**Application for
Certificate-of-Need for
Prairie Island Spent Fuel Storage
Docket No. E002/CN-91-19**

ENVIRONMENTAL IMPACT STATEMENT

**PRAIRIE ISLAND
INDEPENDENT SPENT FUEL STORAGE
INSTALLATION**

DOCUMENT STATUS: FINAL Environmental Impact Statement

Figure 3-4
AVAILABLE SITES FOR ISFSI
 PRAIRIE ISLAND ISFSI

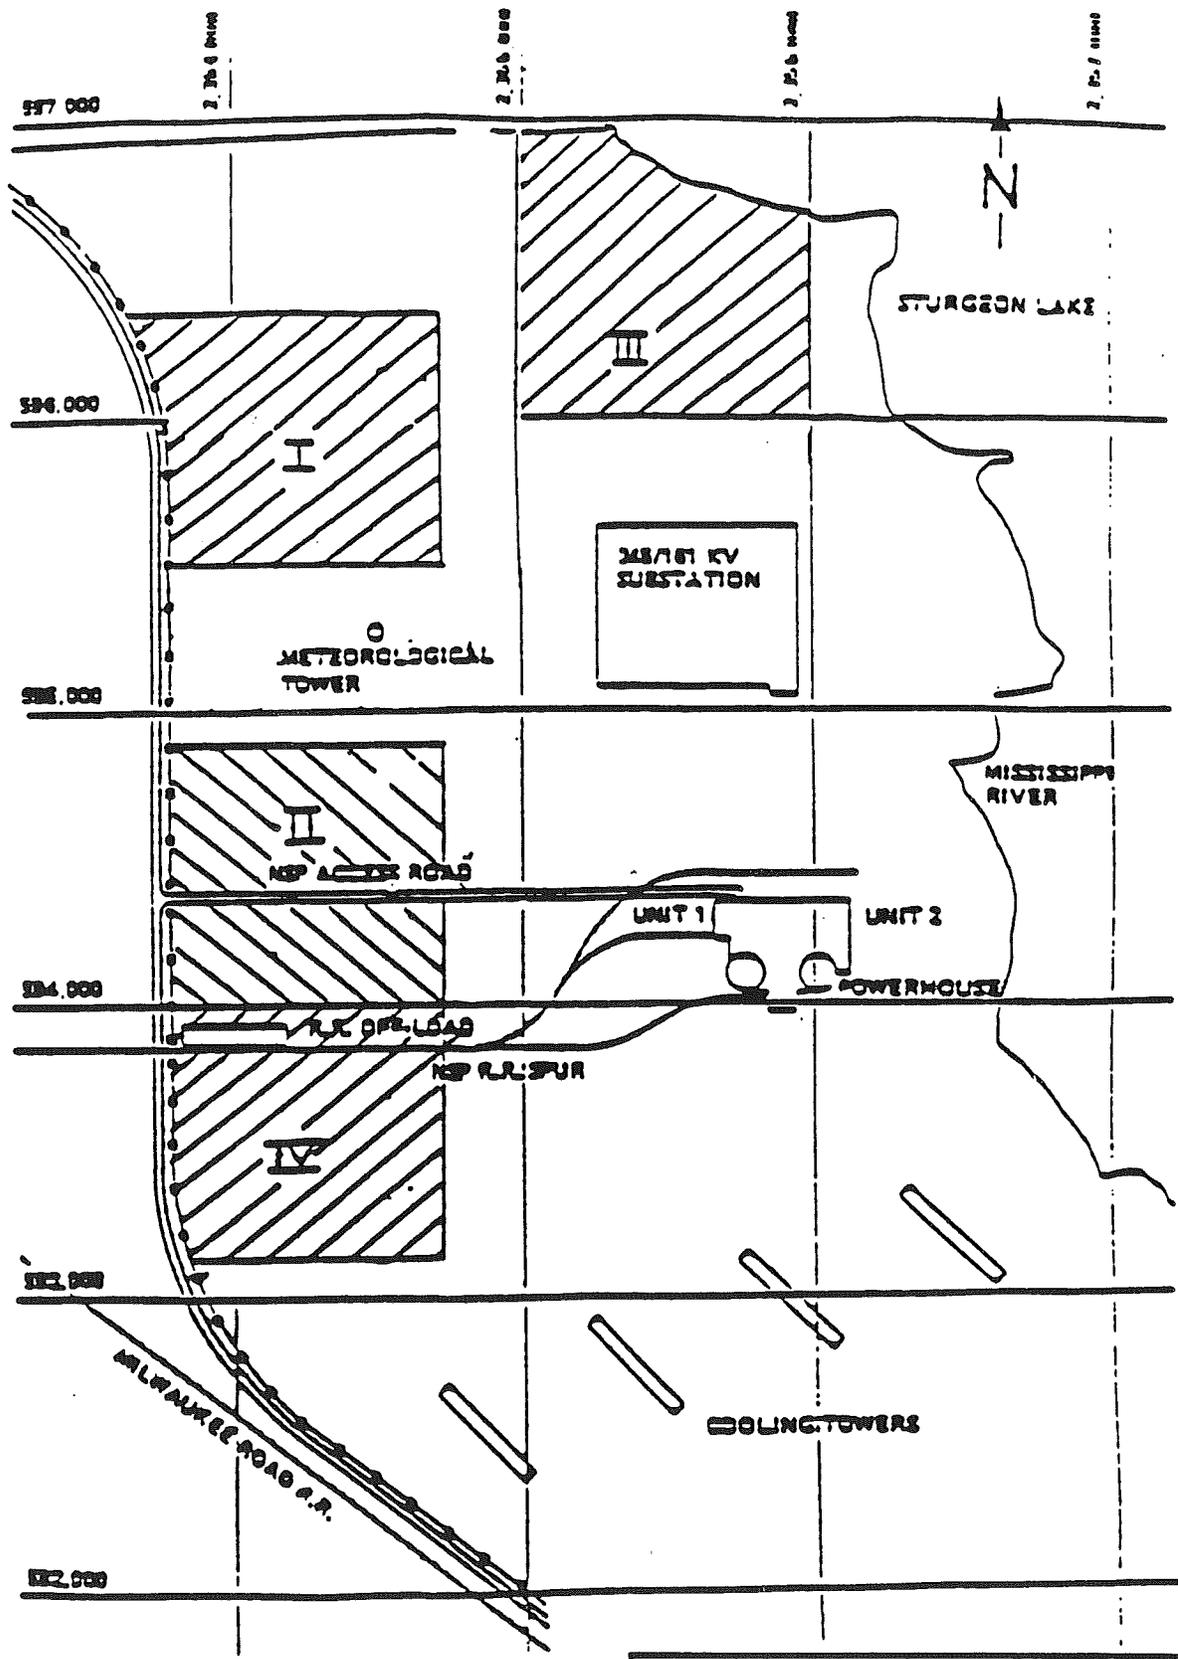
Page 3.3 of this document identifies four alternate sites for the ISFSI on Prairie Island plant property. The four alternate sites are shown on Figure 3-4, page 3.34. NSP has proposed Site I for the ISFSI. In response to the statement of the Minnesota Department of Health in Chapter 6 that relocating the ISFSI from the proposed site approximately 250 yards to the south would reduce the radiological dose to the nearest permanent resident below "acceptable risk" levels. This section analyses the impacts from locating the ISFSI at alternate Sites II and IV. (Alternative Site III is not analyzed because it is approximately the same distance from the nearest permanent resident as the proposed site).

Figure 3-9

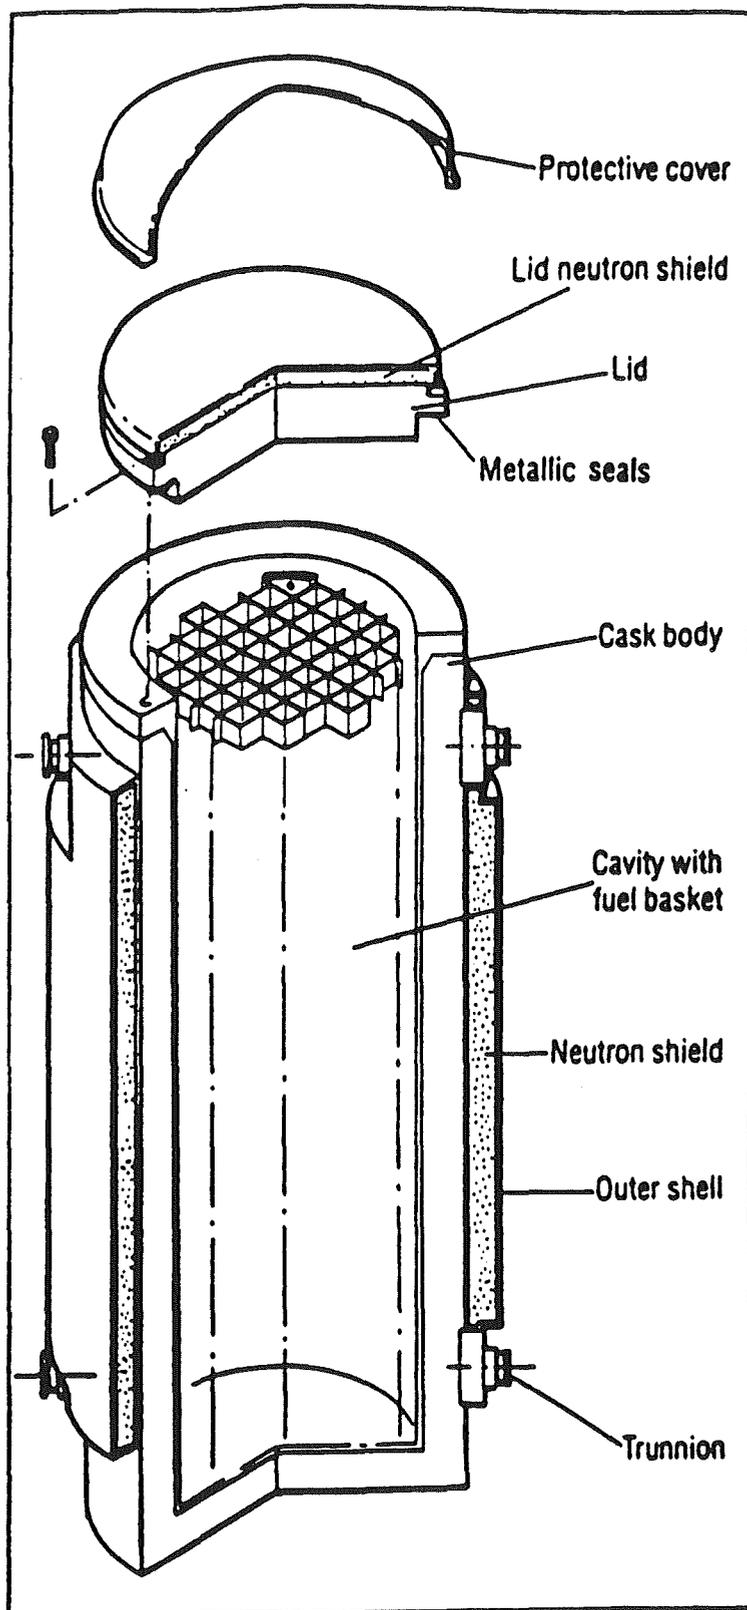
Comments 11B, 19B and 19V requested additional discussion of cask testing. Pressurizing the cask interior to 125% of its design pressure is done to verify the strength of the welds, not to determine whether helium or water can diffuse through the weld. Properly executed welds are as impermeable as the surrounding material. Using water to pressurize the cask interior rather than a gas is the safest, most reliable method to verify weld strength, and is the standard method used for pressure vessels. Radiographs and dye-penetrant tests of the cask welds will also be performed to verify weld integrity. For further discussion of cask testing, see NSP comment A.2 (NSP comment letter, #10), for a response to 19B, and NSP comment A.9 (same submittal) for a response to 19V.

Figure 6A-1
ALTERNATE SITE II LOCATION

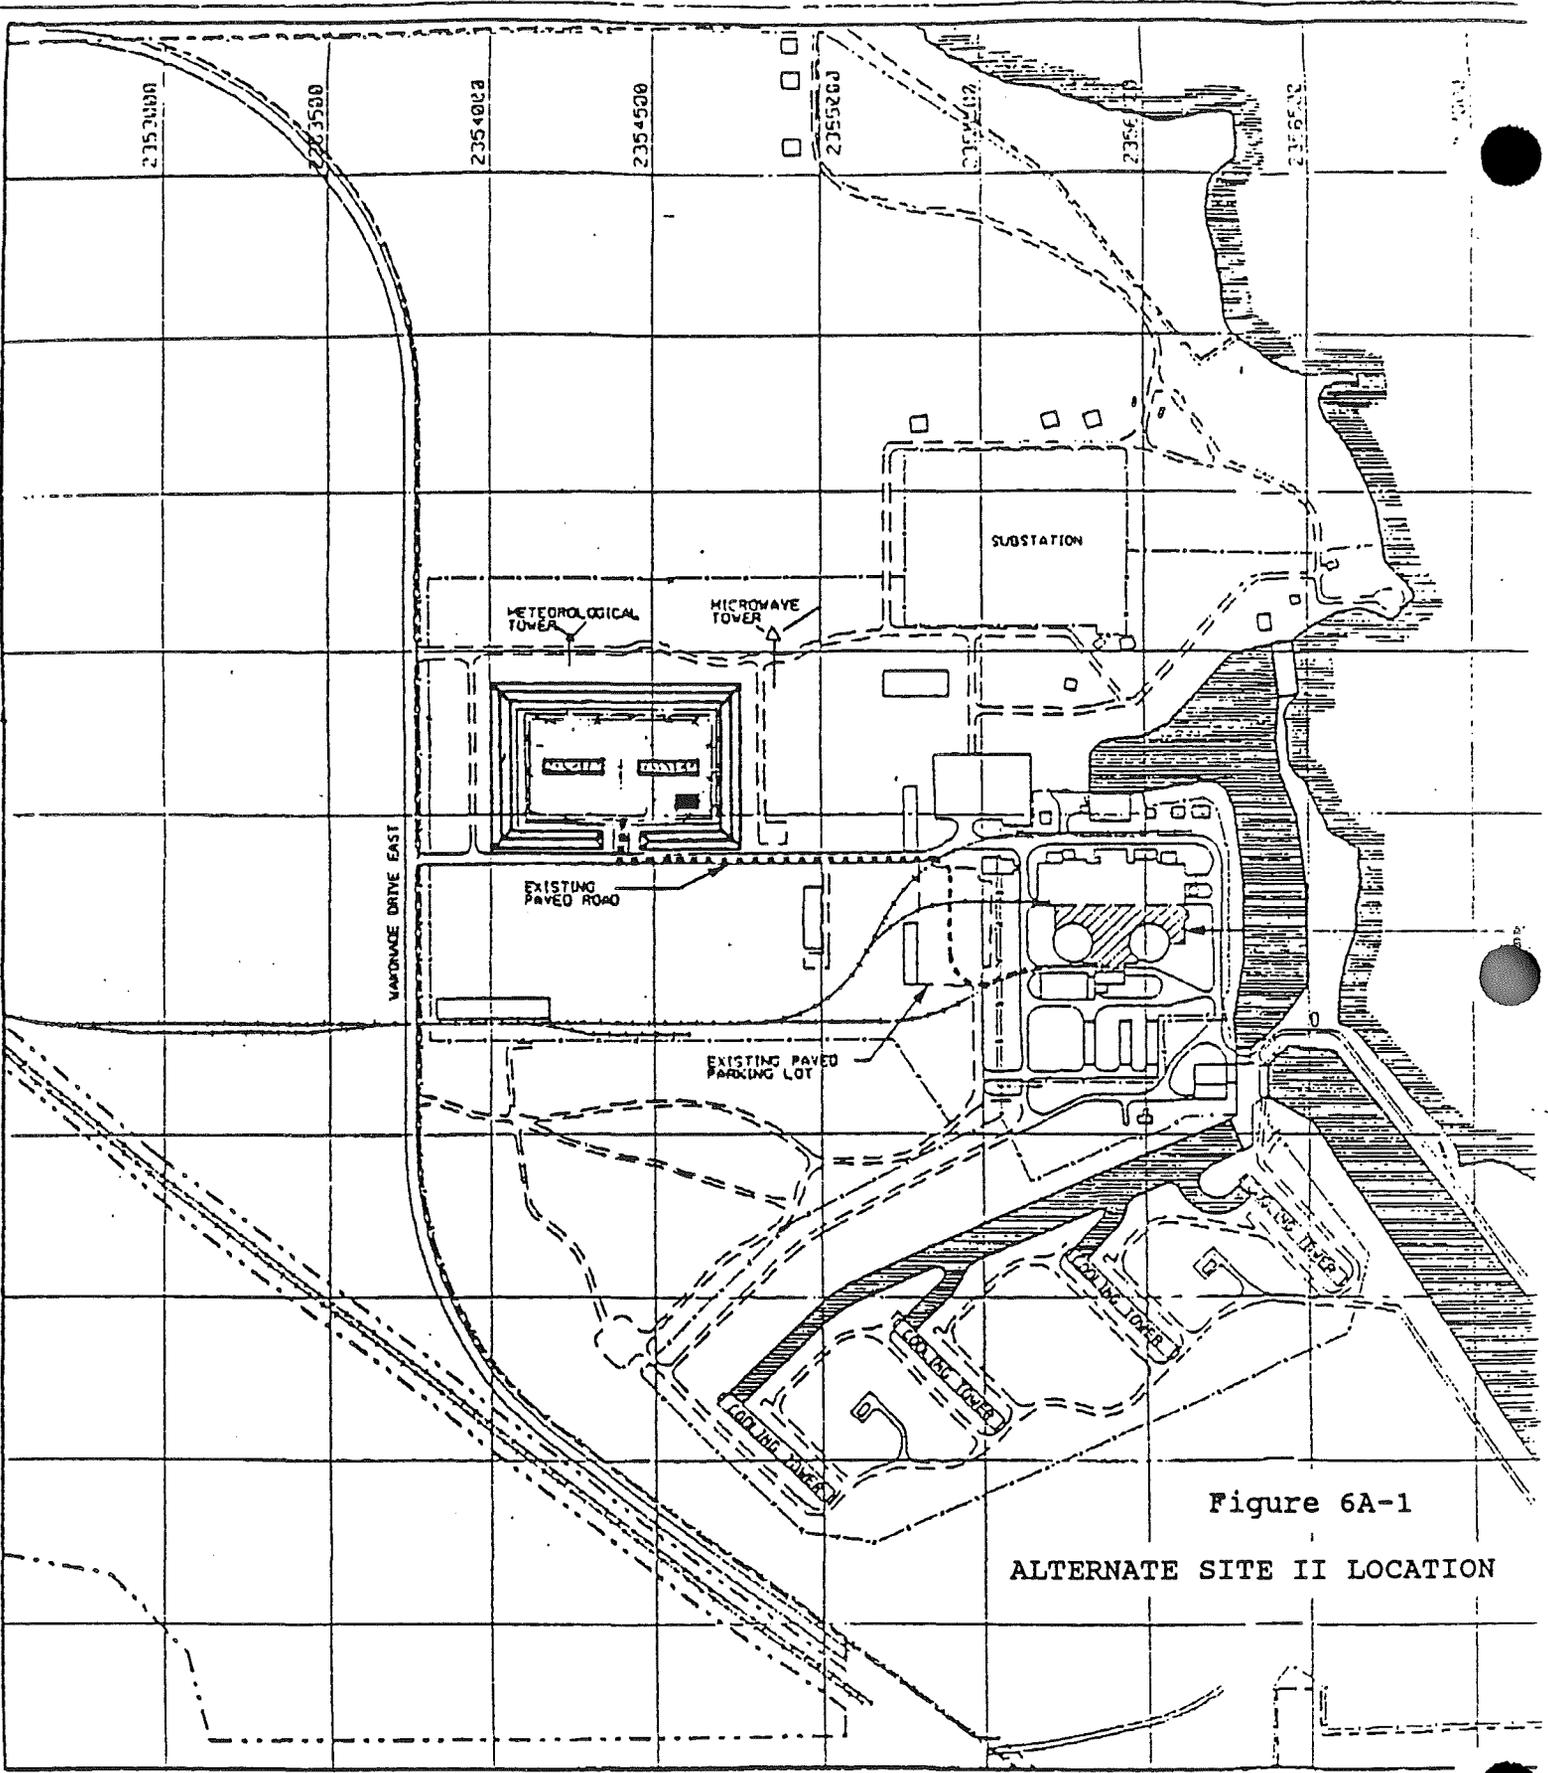
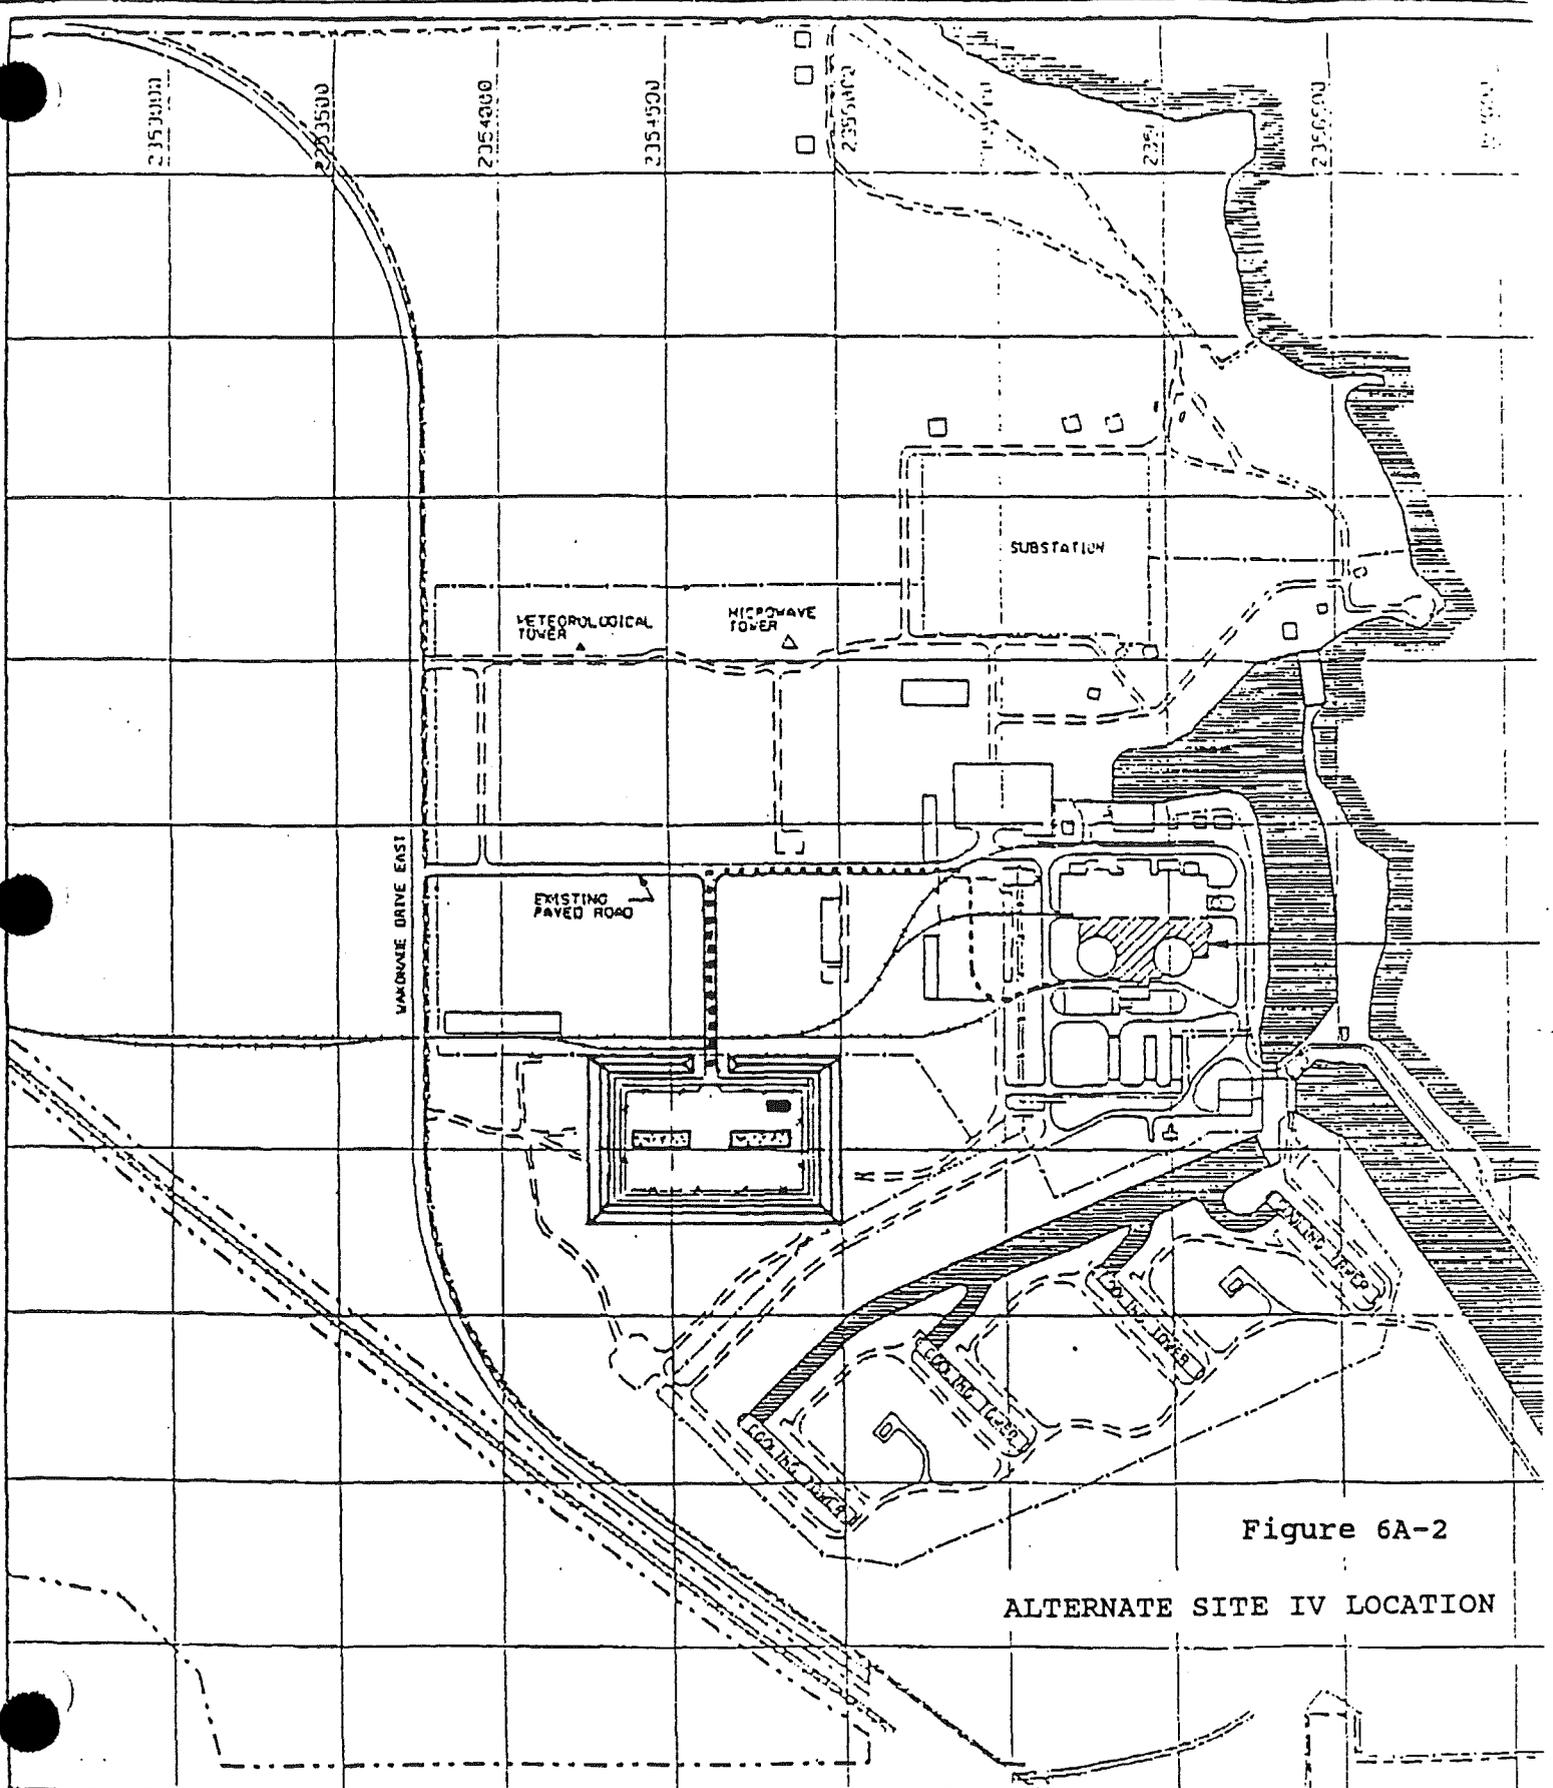
560 acre Prairie Island plant property. Use of alternate Sites II or IV, however, would likely result in a different configuration of the concrete pads and casks. Figures 6A-1 and 6A-2, page 6A.7, show possible layouts of alternate Sites II and IV.
